MINUTES OF MEETING OF THE OGUNQUIT HISTORIC PRESERVATION COMMISSION on 01/04/2017

Subject property is 111 Beach Street with a previously approved reconstruction permit for a building built in approximately 1908 and destroyed by fire in 2015 with the replacement plans reviewed and approved by the Ogunquit Historic Preservation Commission on 10/14/2015. This property possesses Historic Importance as a part of the establishment of Ogunquit Beach as a world class beach resort, along with having Neighborhood and Architectural Significance.

- Situation :The Owner of 111 Beach Street is seeking an after the fact Design Review approval for construction and material changes made without having permitting by the Ogunquit Planning Board for the alteration in window locations and a substantial increase in window sizes on the North and West first floor elevations along with the addition of two large bi-fold glass doors in the southwest corner of the building, one is a 3 glass panel bi-fold and the other is a 4 glass door bi-fold that folds out onto the public side walk that now exists and where the owner and builder believe that a yet uncompleted survey of the building under construction will

West River Elevation
1/4"=1'-0"

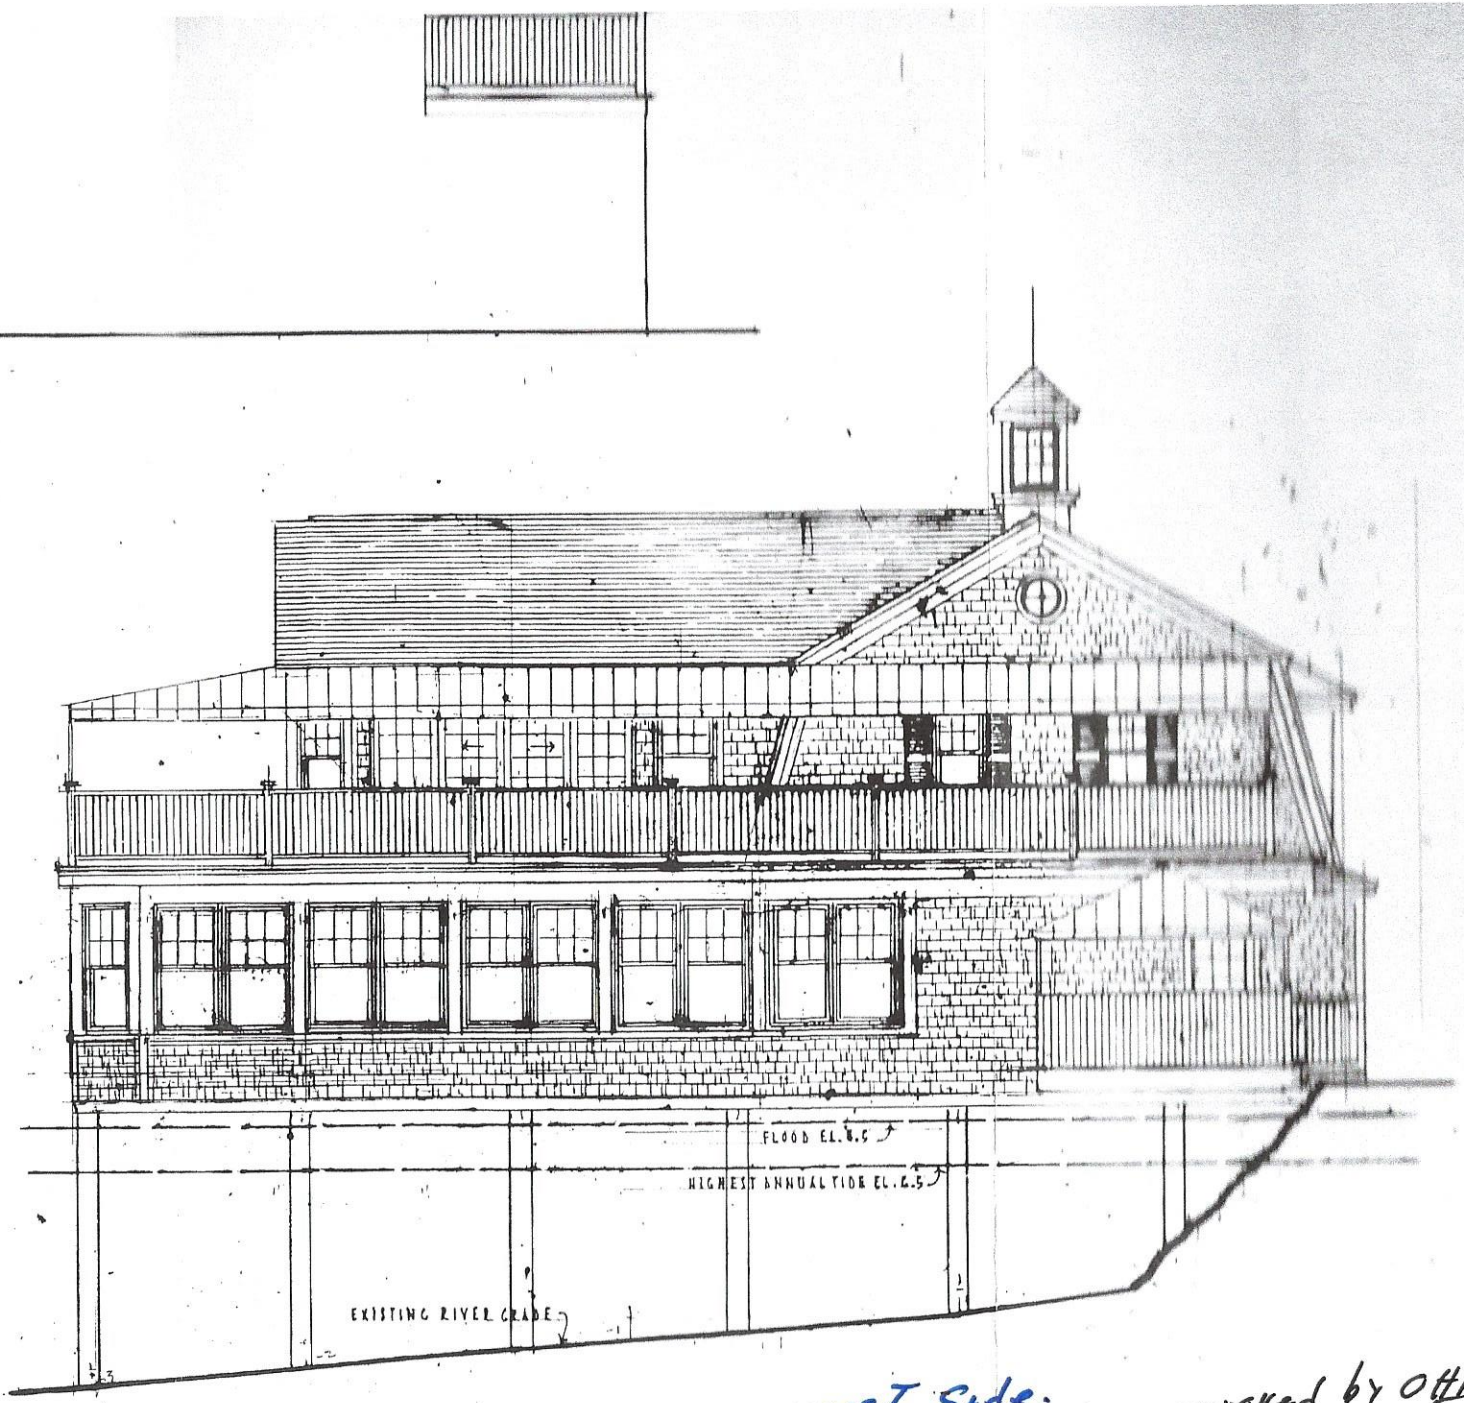
- The double hung windows on the west side that were shown on the approved plan were six over one and easily 24 inches or shorter in height than the presently installed double casement window units. These casement units have a plastic insert mullion covering the top one third of the glass area; this mullion gives the appearance of thin white tape applied to the glass. These window units open only four inches as a safety precaution of anyone fall out through the screen on the inside of the window. It can be opened full for cleaning and due to being used in a public area the glass is safety glass to prevent accidental breakage due to falls or trips that could allow a fall of 10 feet or more into the river or mud.

North River Elevation
¼"=1'-0"

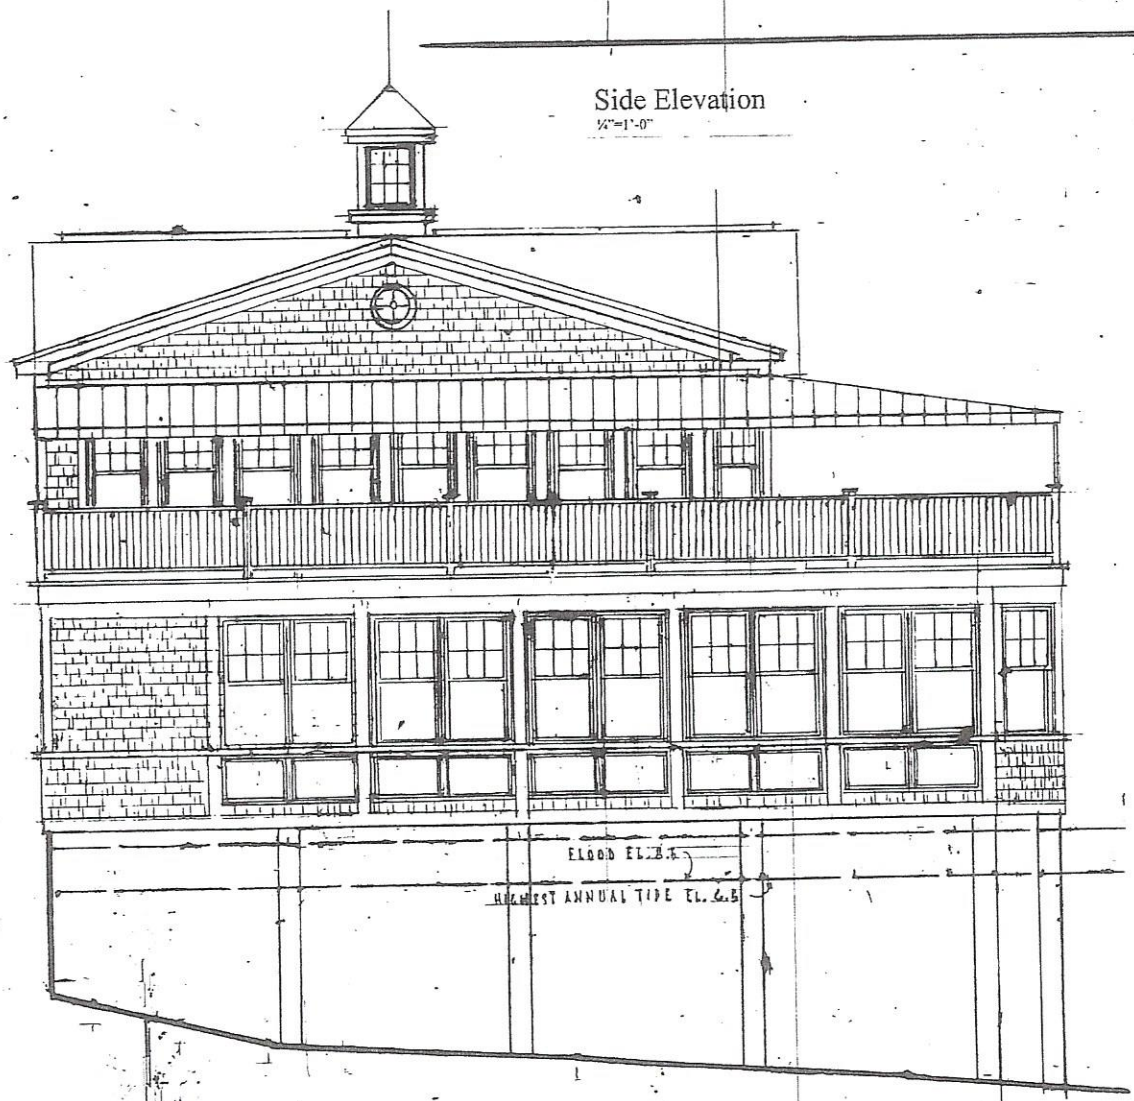
changes made To The
aprroved plan as
presented To The OHPC
and The O.P.B.

Front Elevation
3/4"=1'-0"

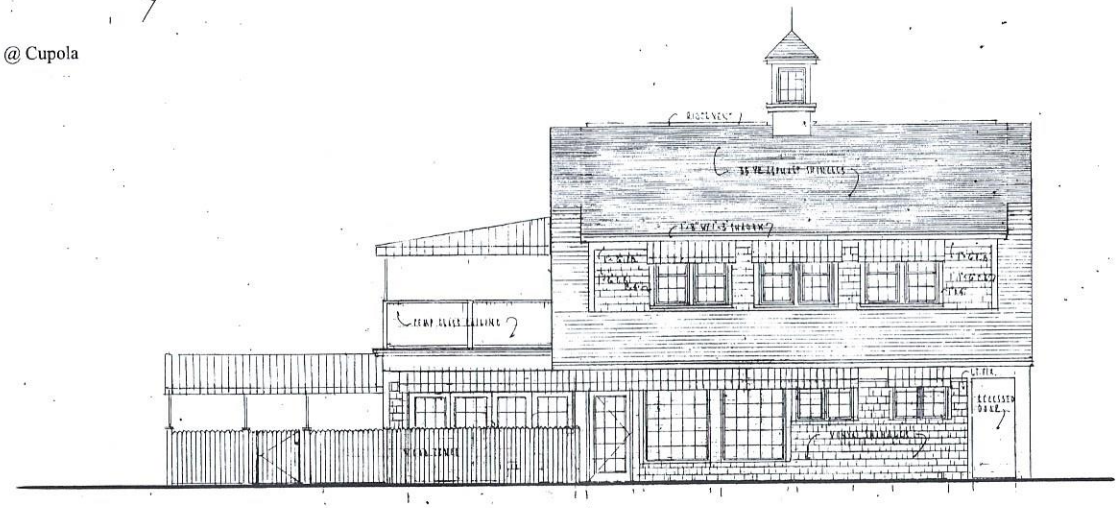
owner and builder request
"After The Fact" approval
for changes asbuilt.

Mindful of the economic impact of changes to building and components already built the Commission has agreed to recommend to the Ogunquit Planning Board voluntary changes to the existing building that the Applicant, Roger LaPierre and his builder Douglas Gaines are willing to make.
To reduce the size of the two remaining large windows on the south elevation.
To change the proposed second floor deck glass railing facing south to a traditional composite railing with balusters.
To consider moving the 4 door Bi-fold door slightly to the west in an attempt to achieve better delineation of the new second floor deck from the two story building.
To remove the small one third of the window mullions on all west and north facing first floor windows or to obtain larger diameter mullions that in-fact give the appearance of an actual wood mullion.
To acknowledge the need to add a door and remove a window on the second floor north facing elevation do in part to the State Fire Marshals requirement that there must be two exits on the second floor deck.

On the South street side westerly corner, we acknowledge the need for a street side fence to prevent the general public from entering and leaving the building when the 4 door bi-fold door is open into the sidewalk by 3 feet or so. This is subject to a survey showing that Roger LaPierre in fact holds title to that section of the public side walk allowing the swing into the side walk when open and room to place a fence.

A4

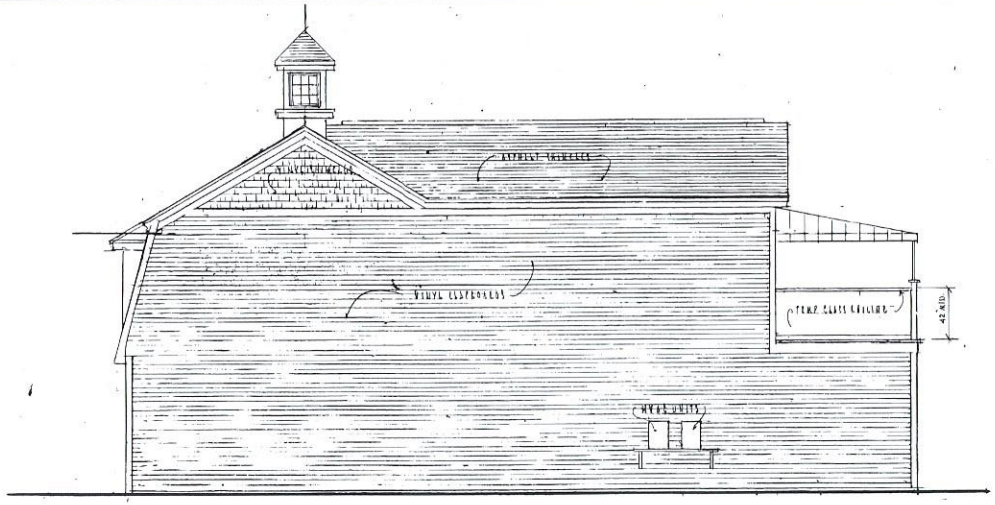
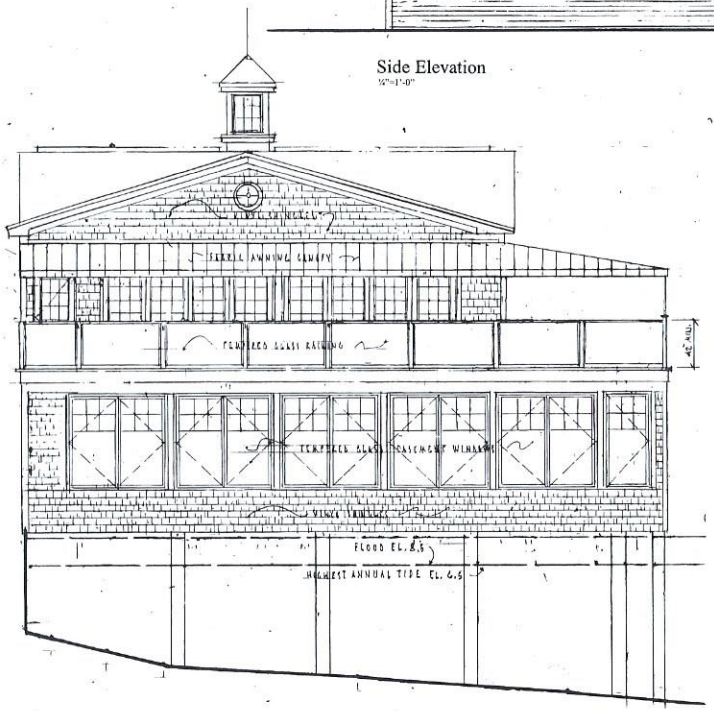
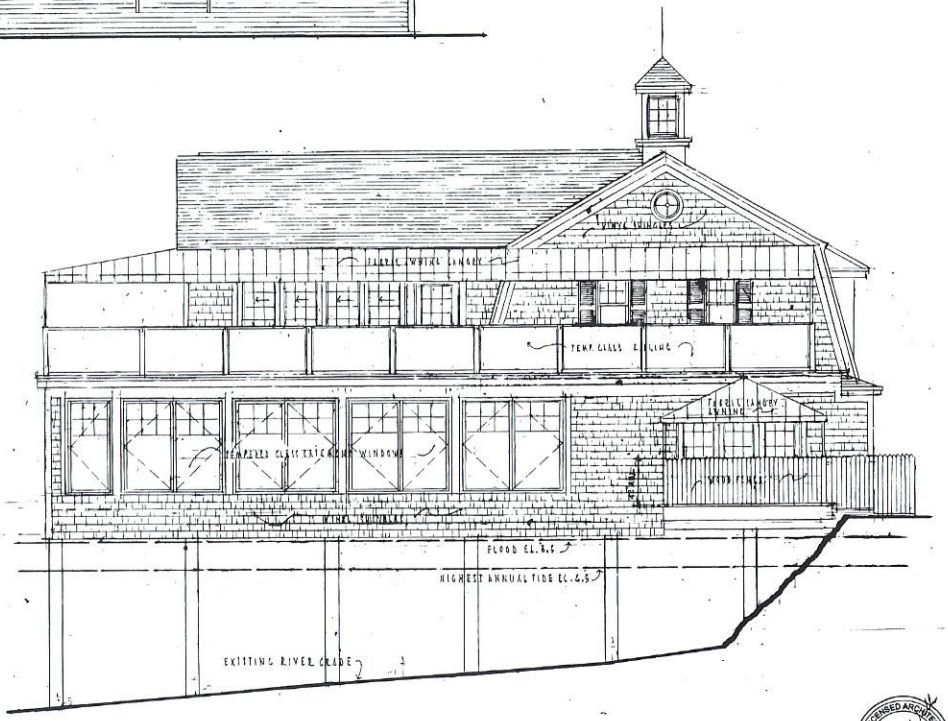
owner and builder request
"After The Fact" approval
for changes as built.
